# EDUCATION CENTER REUSE

1426 N QUINCY ST

# JOINT MEETING 4: AGENDA

BUILDING LEVEL PLANNING COMMITTEE  
PUBLIC FACILITIES REVIEW COMMITTEE

# What we heard about site design last meeting and subsequently

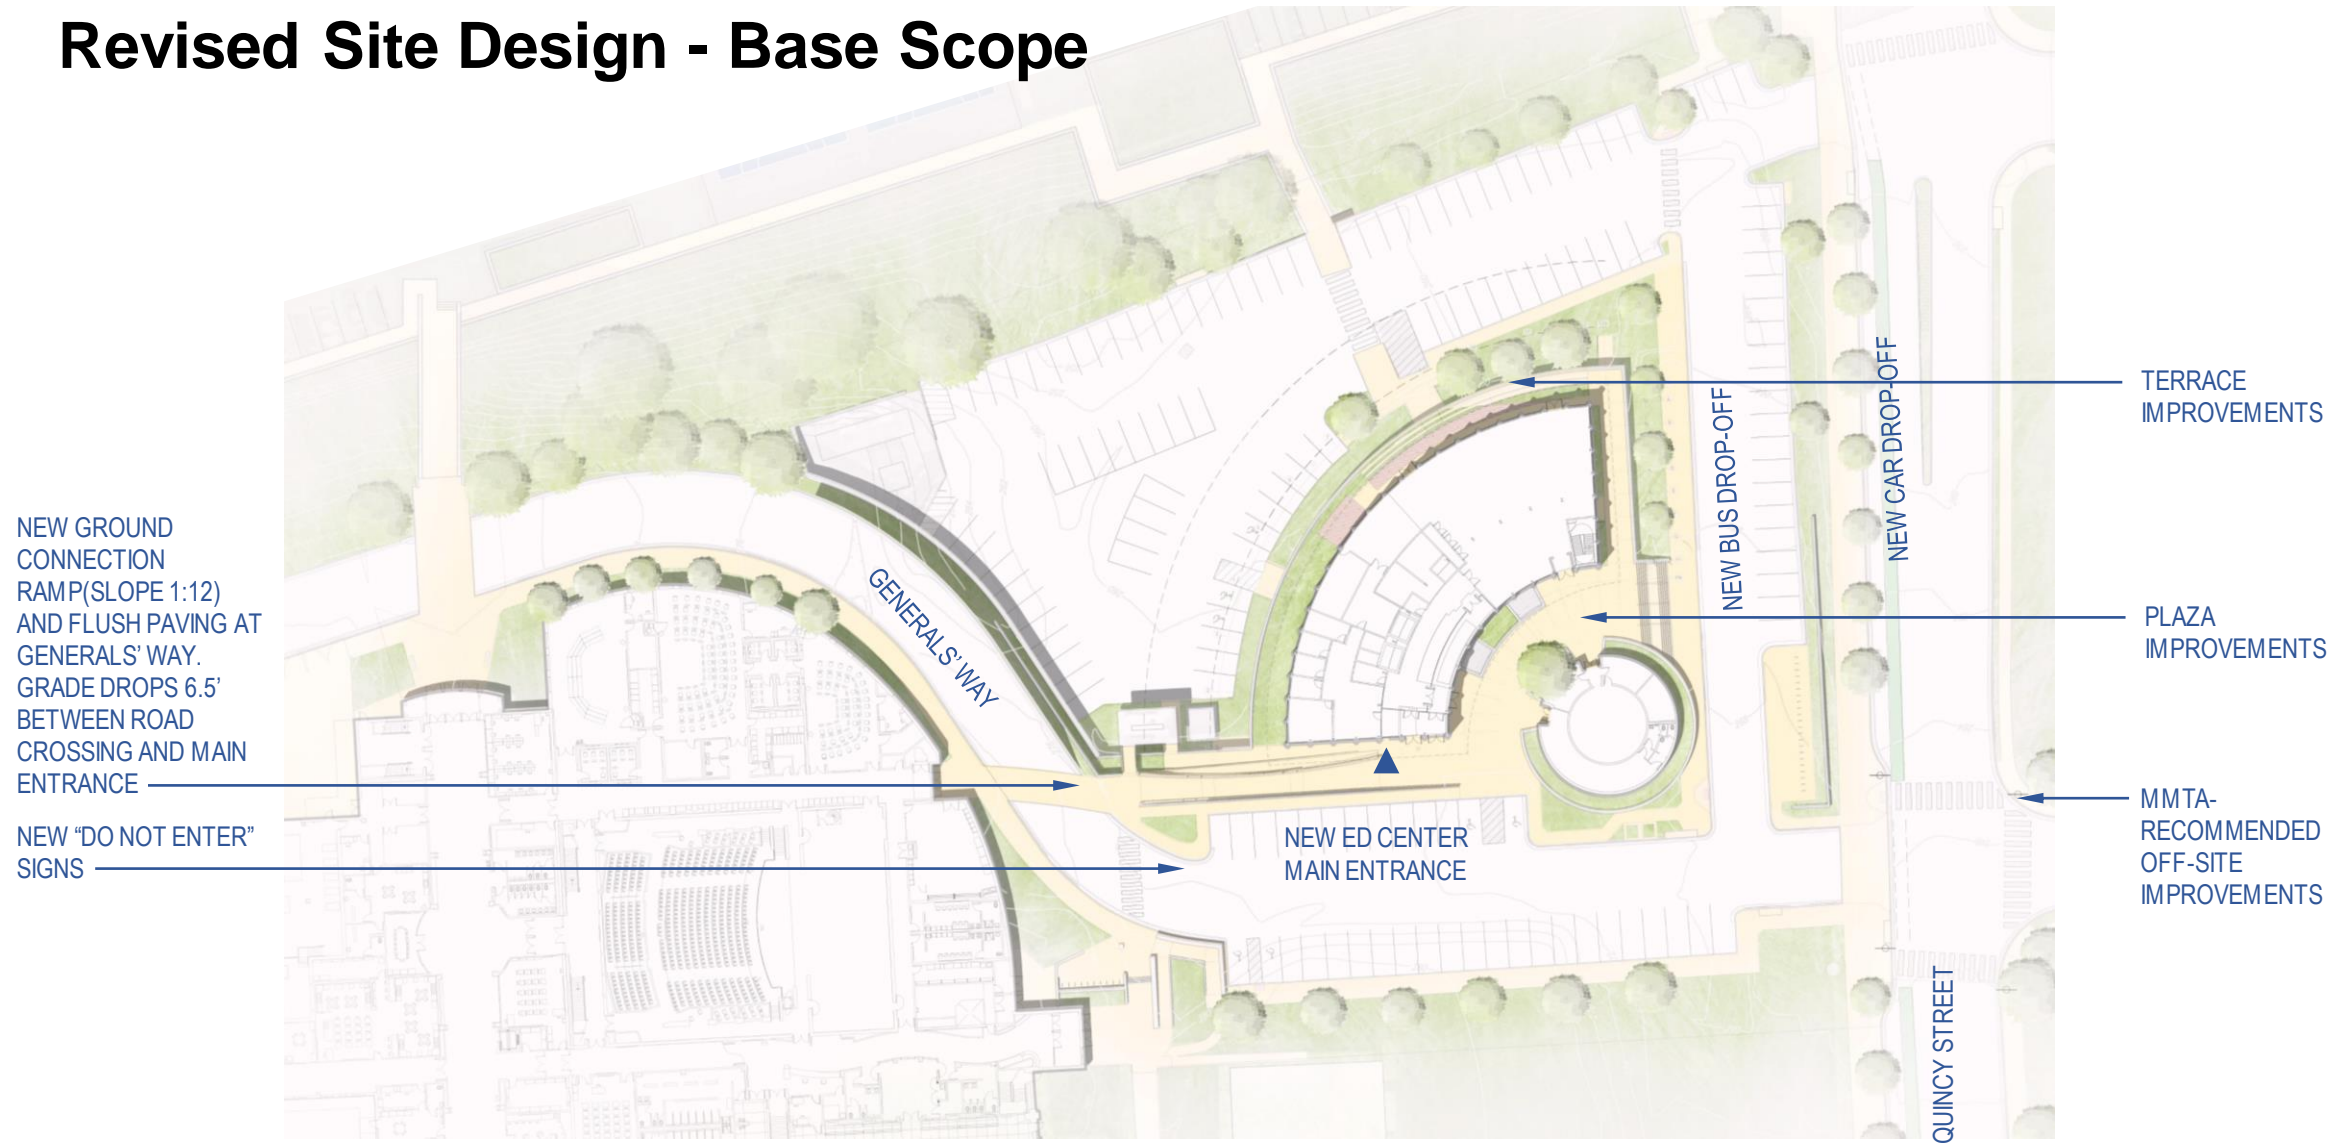
- Ramp and Stair to W-L
  - Need to make it large enough to accommodate student volume between classes
  - Ramp should be the primary access to support Universal Design

- Replace Parking lot with 70 spaces and bus drop-off
  - Consistent with Transportation Recommendations
- Recreational Opportunities – Additional Capacity for 500-600 New Students

- Consider building multi-use court & upgrading adjacent unimproved space to irrigated rectangular athletic field
    - Supports school fitness curriculum by providing a flexible space for students to play multiple sports

- Provides activity space for all ages
    - Consistent with PSMP Update guidance to create flexible spaces accommodating different recreational activities

- Consistent with CFS guidance to encourage joint or shared use of facilities as improvements would also benefit nearby schools and community
  - Must accommodate fire truck access to building

- Terrace extension and bike canopy
  - Desirable bike parking cover
  - Undesirable addition to the building
- Adherence to Budget requires base scope and alternate scope

# What we heard about building design last meeting and subsequently

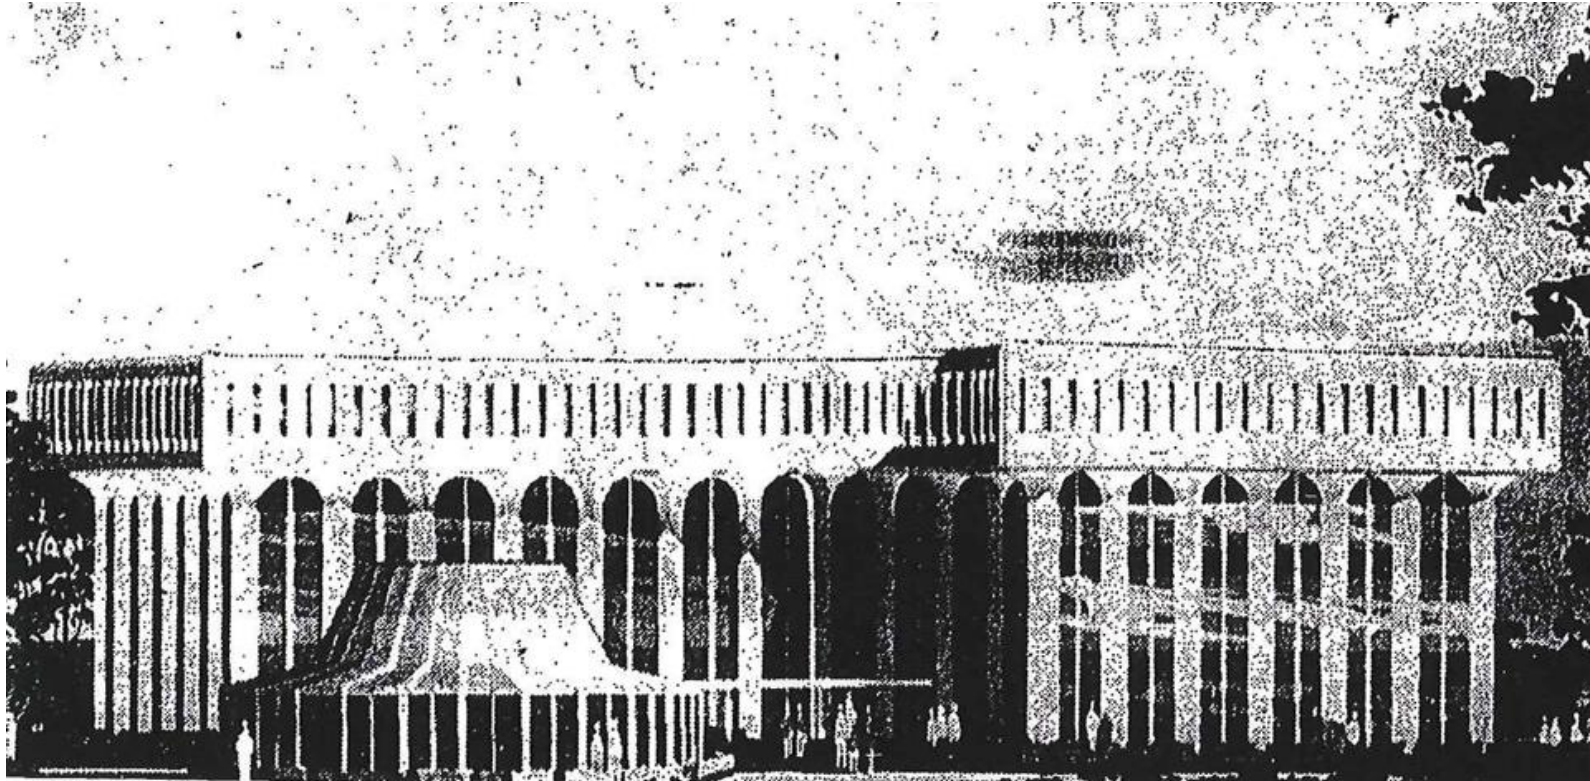
- Proposed community uses on first floor are generally appropriate
- Overall exterior
  - Solar exposure is a serious problem for creating High Performance Learning Environments and the new glazing should address it

- The Education Center existing Energy Use Intensity (EUI) is over 200 while the County use permit typically requires much less. As an example, an EUI range of 26 to 56 was required for the recent New Elementary at Reed project.

- Relief that that the concrete panels are stable and require minimal repair
  - Concern about the overall impact of operable vents and frits on the architectural image

- Enlarging openings at ground level to accommodate school use
  - Mixed comments some recognizing that it was desirable for school use and some concerned about the impact on the historic character

- Adherence to budget requires carrying the bridge concept must be an alternate as it was not in the CIP project budget
